THE UNIVERSITY OF
SYDNEY

13 August 2020

Re: University of Sydney- Engineering and Technology Precinct – Mod 1 (SSD - 8636_Mod_2)

Figure 2: Extract from attachment 2

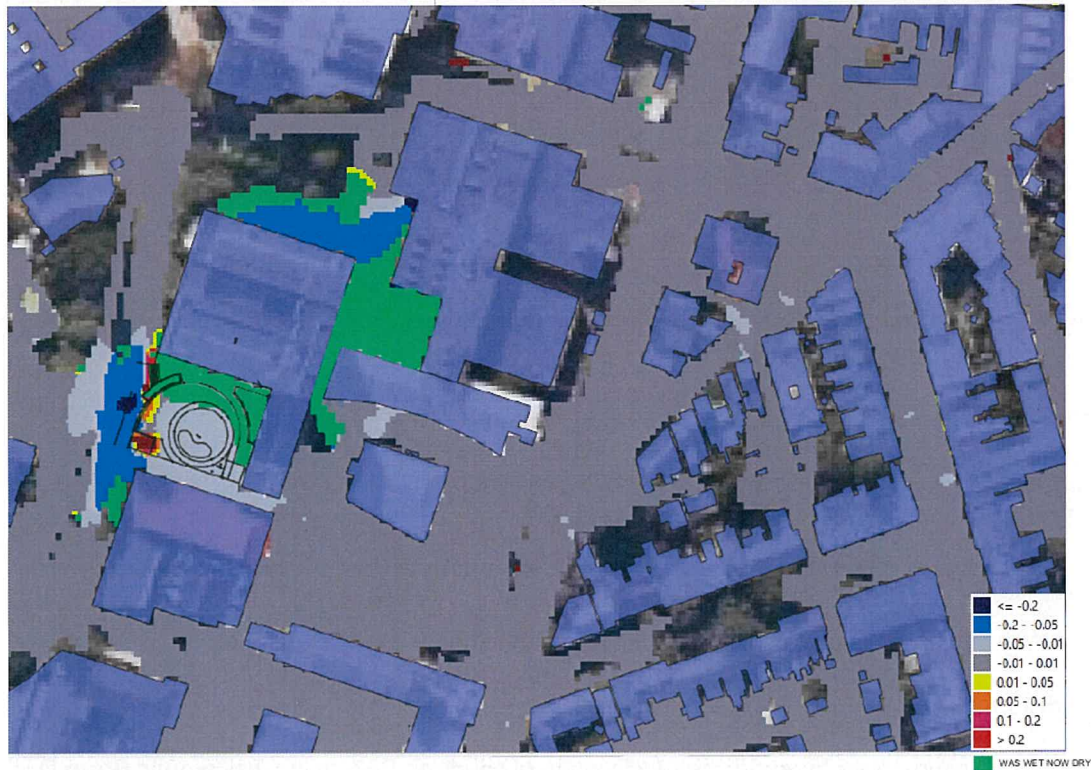
The following detail responds to the commentary provided under Condition B37 in the CoS's letter dated 15 July 2020 requesting further clarification and information. It is understood that the CoS is seeking clarity on;

- Flood depth just outside the building; and
- Changes to Water quality treatment

The flood model has been updated to include the revised basin and landscape design as shown in attachment 3 and changes described in detail below under Condition B38. To provide clarity regarding the changes to the flood level, the flood level afflux is shown below. The conclusion remains that there is no downstream impact traceable to the development. The flood depth that was previously shown outside the building has been addressed in our response to B38 below.

Figure 3: Extract from attachment 2

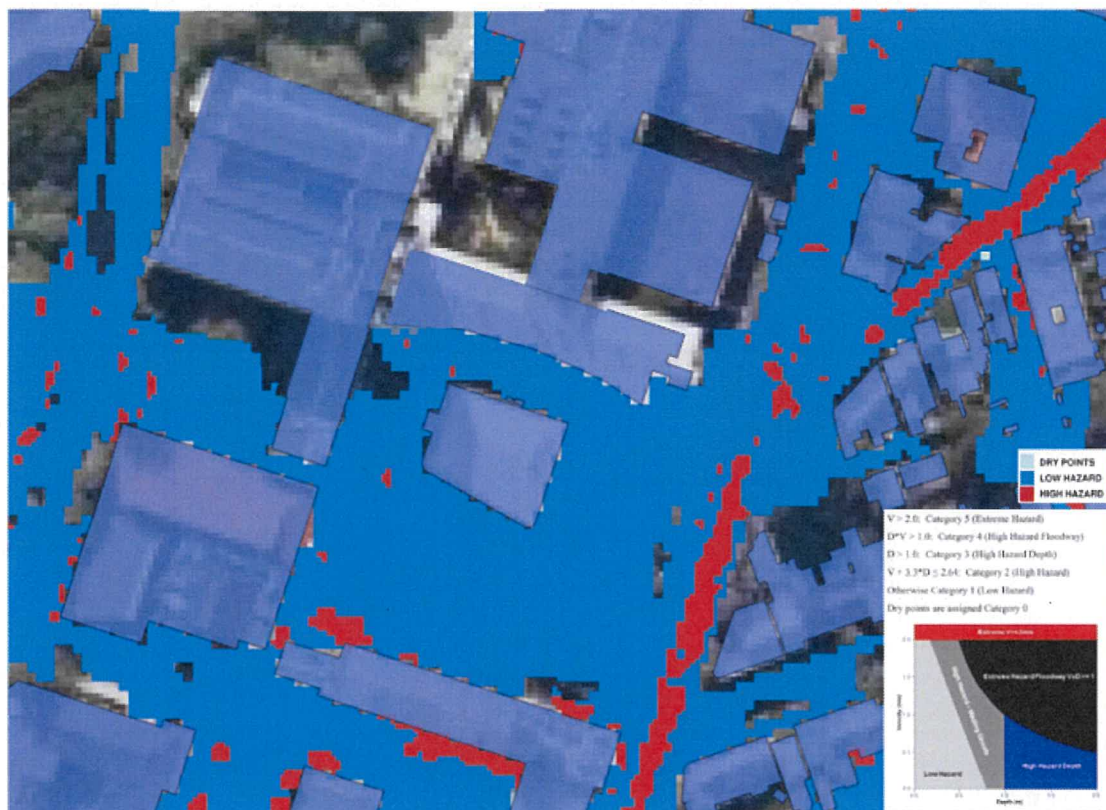
The CoS has stated that the removal of this clause is subject to the removal of the condition 37 where further clarification is requested. The CoS goes on to request further details of the proposed changes to the landscape and its effect to flood risk. The following details have been provided to assist provide clarity. It is understood from the commentary in their letter dated 15 July 2020 that the CoS is looking for the following:

- Plans with sufficient levels and gradients for the pavements, sections and details to confirm DDA compliant equitable access on the surrounding paths; and
- The risk of people tripping or falling into the basin has been 'designed out' of the scheme'

As part of the redesign of the plaza, Basin D's profile and gradients have been raised to create a shallower basin whilst maintaining the OSD storage and water quality requirements for the development and maintaining no downstream impact to flooding.

The flood hazard for the proposed altered design compared to the approved design has therefore been reduced from high to low (as categorised by NSW Flood plain development manual appendix L3, figure L1). Refer to the flood map extract below from attachment 2

Furthermore, the revised landscape design's improved circulation, gradients, levels and edging has improved circulation and further 'designed out' risks of tripping or falling into Basin D. The revised bio-retention basin D has incorporated batters that are traversable (maximum 1 in 4 grade) further designing out any ability to 'fall' into the basin.
